City of Sonoma Planning Commission **AGENDA**

Special Meeting of July 18, 2013 -- 6:30 PM
Community Meeting Room, 177 First Street West
Sonoma, CA 95476

Consideration and possible certification of the Revised Final Environmental Impact Report (RFEIR) for the Mission Square project; Consideration and possible action on planning approvals for the Mission Square project, including a Use Permit, an Exception to the parking standards, and Site Design and Architectural Review.

Agenda Item Title: Review, consideration and possible action on the Mission Square project, a mixed-use development proposed at 165 East Spain Street. Items to be addressed include: 1) Review and certification of the Revised Final Environmental Impact Report (EIR); and 2) Consideration of application for Planning approvals, including a Use Permit, Site Design and Architectural Review, and Parking Exception.

SITE PLAN
SCALE: 1" = 20'-0"

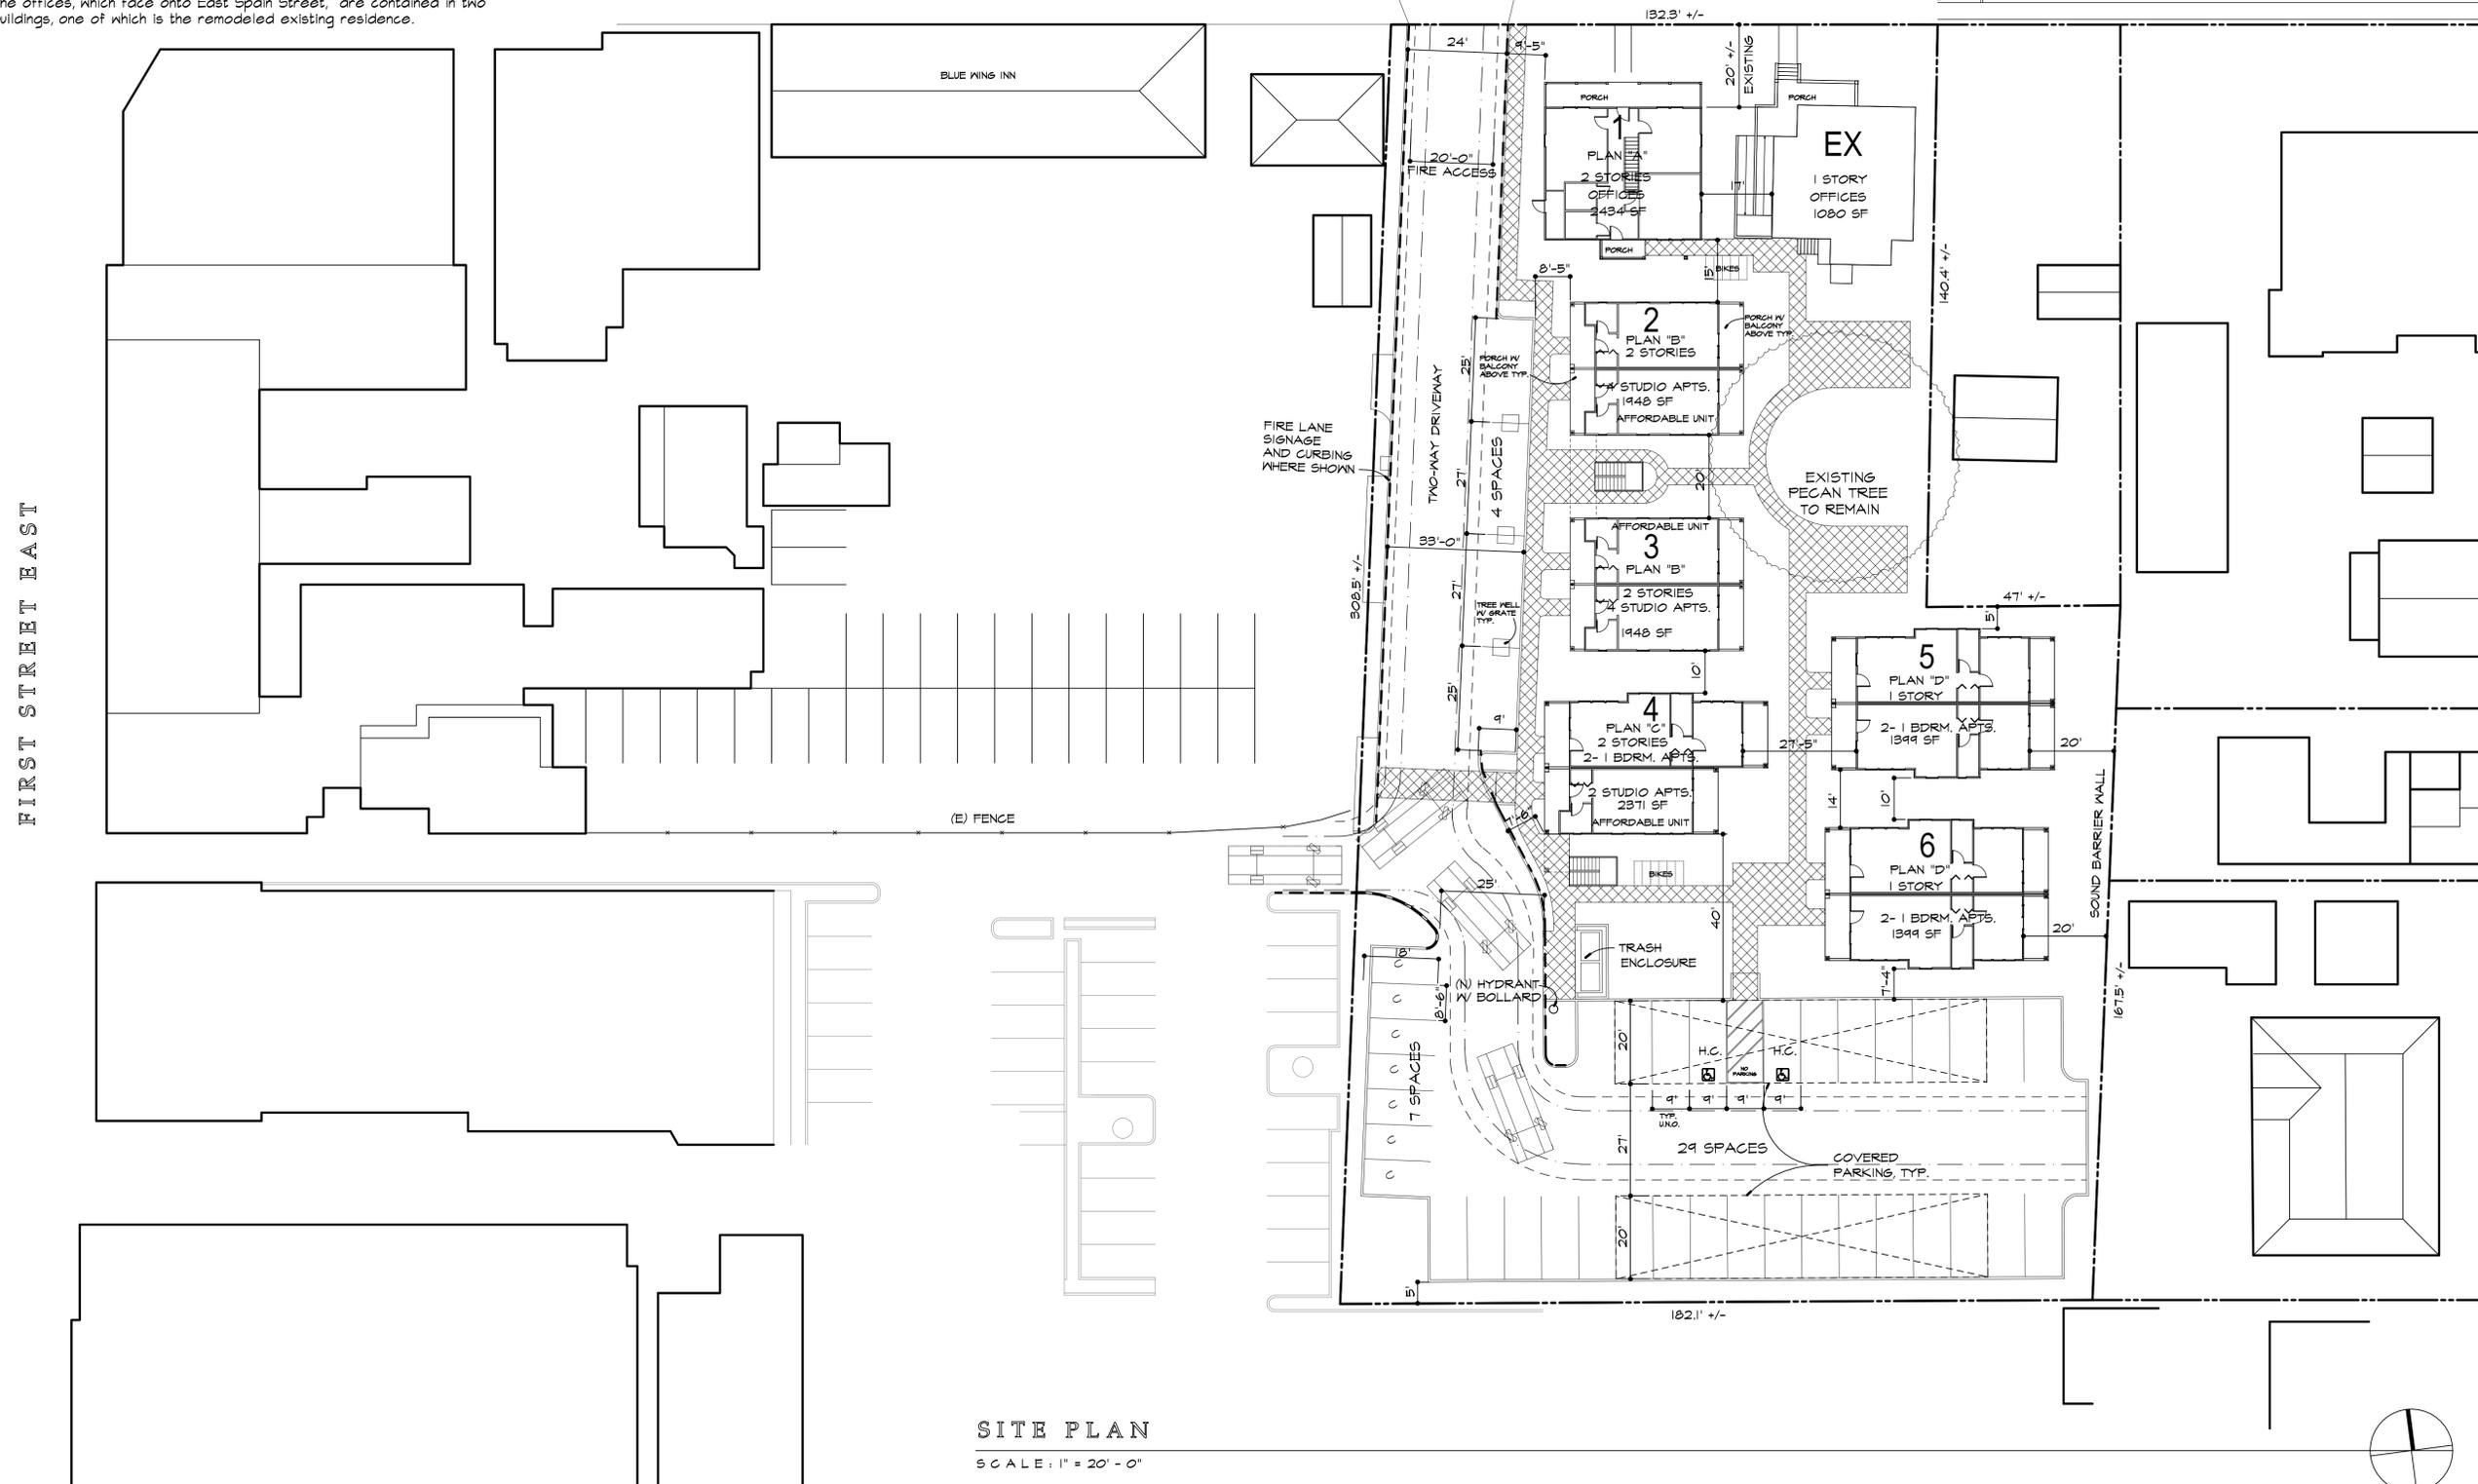
It is important to note that in contrast to previous reviews, the Planning Commission is considering both Certification of the EIR and approval of planning entitlements for the project. In this regard, staff would note that some minor revisions to the site plan (Sheet SP1 Revised 10-28-10) have been made, primarily to demonstrate compliance with Fire Department requirements and provide more open space in front of some apartment buildings, as follows:

- Fire truck access requirements (turning radius and turnaround) are illustrated on the plan along with the location of red-curbings where parking would be prohibited for the internal fire lane.

The site plan included in the Revised FEIR (Figure 1-2) does not reflect these miscellaneous revisions. However, these adjustments are minor and do not affect the EIR analysis.

2. The project shall be constructed and operated in conformance with the project narrative, approved site plan (Sheet SP1 revised 10-28-10), and building elevations (Sheet E1 revised 5-14-08), except as modified by these conditions and the following:
